Technical Bulletin

Bulletin No: TCH-002-014 Effective Date:2/29/2012 Cancels: N/A Page: 1 of 2

Subject: Bendix® Air Disc Brake Actuator Vent Hole Orientation

Air Disc Brake Actuator - Bottom View Shown

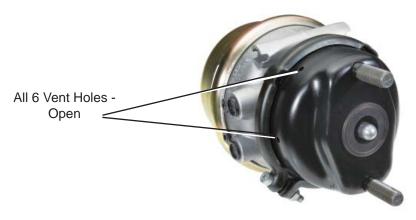
Since 2006, BSFB has made improvements to the caliper sealing interface, boot, and return spring coating. Along with these improvements, the actuators were tested – comparing those with five(5) holes plugged and the bottom open to those with six (6) holes open – with negligible performance differences. This means that, as long as the bottom hole (closest to the road surface) is open the other holes do not need to be plugged.

Plugged Vent (All other vent holes may be open or closed)

Open Vent (Bottom vent hole <u>must</u> be open)

Action: Vehicles with Bendix® brand air disc brake actuators should be inspected to verify that the vent hole closest to the bottom of the actuator is open. If a plug is found in this location, it must be removed to allow proper draining. The removed plug can be discarded. It is not necessary to place it in the other open port. Removal of the plug is easily completed by pulling it out with a pair of needle nose pliers. Note that the removal of this plug will not impact the actuator warranty.

Since testing has shown that having more than one vent open does not impact either performance, or the life of the product, the plugs are being removed from all Bendix air disc brake actuator designs. This will eliminate the possibility of water and contaminants collecting in the actuators, reduce part numbers and inventories, and make servicing the actuators easier.
